## Product Information Notification (PIN)

### PN 25320-X and PN 25323-X Bonnet Material

**PN 25320-X and PN 25323-X Bonnet Material**

Figure 2. PN 25320-1 with cast bonnet PN 23401-2: Reference Dimensions

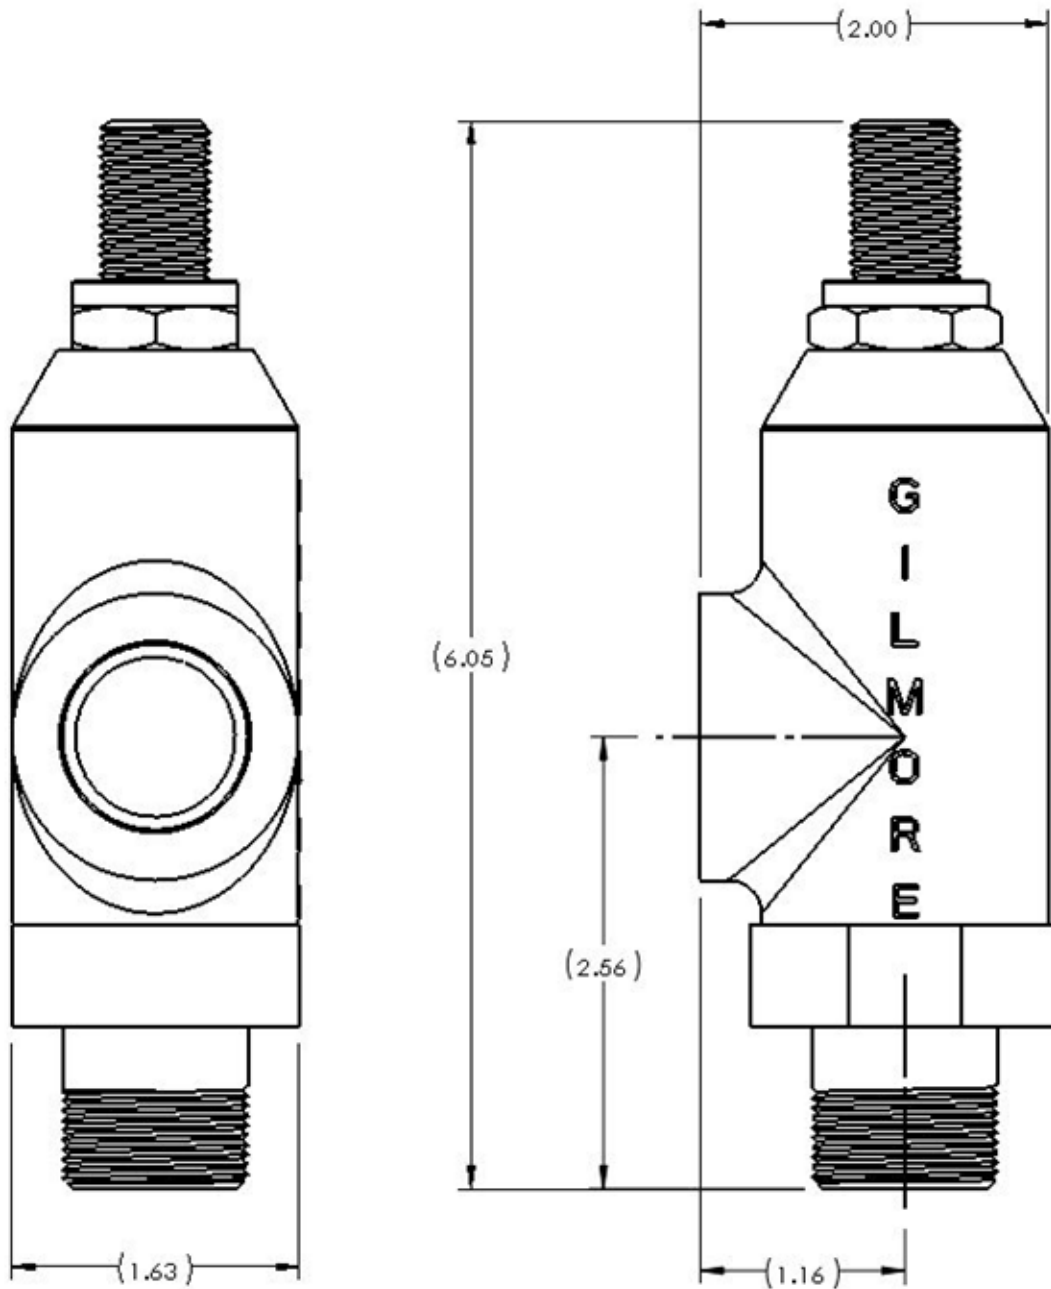
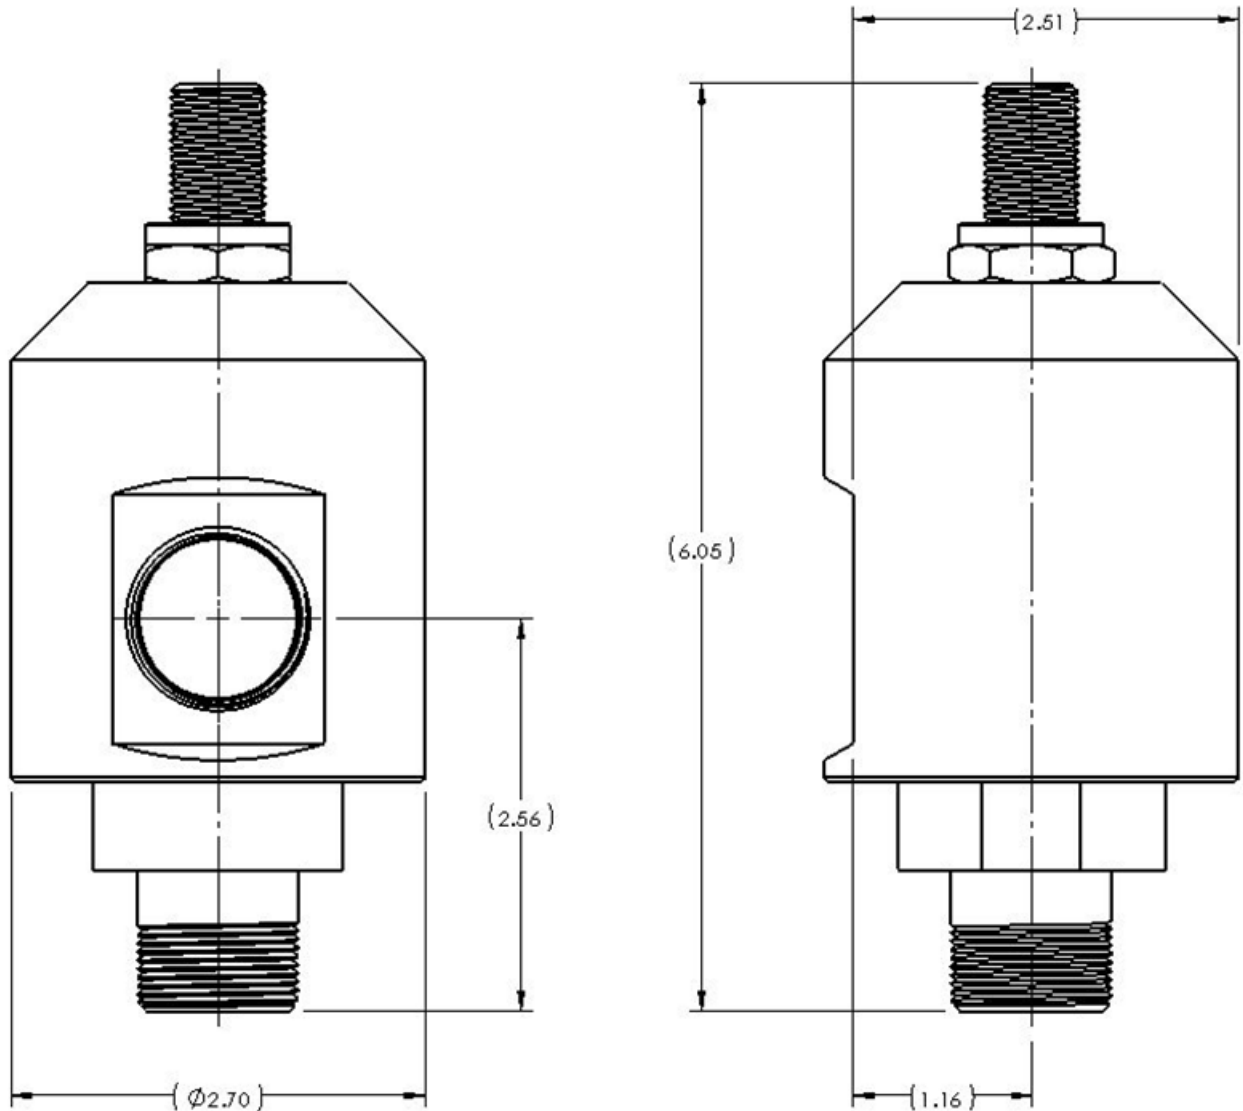
Gilmore announces a bonnet change to our Hydraulic Relief Valve series: PN 25320-X and PN 25323-X. For the relief valve part numbers listed below, the CF8M bonnet casting will be temporarily changed to 316 SS machined bonnet until new castings can be restocked.

Please note that while this change increases the valve envelope, it does not affect the valve's port location. The bonnet maximum width has now increased from 2.00 inches to 2.70 inches. The porting location for these bonnets are identical and can be swapped out directly.
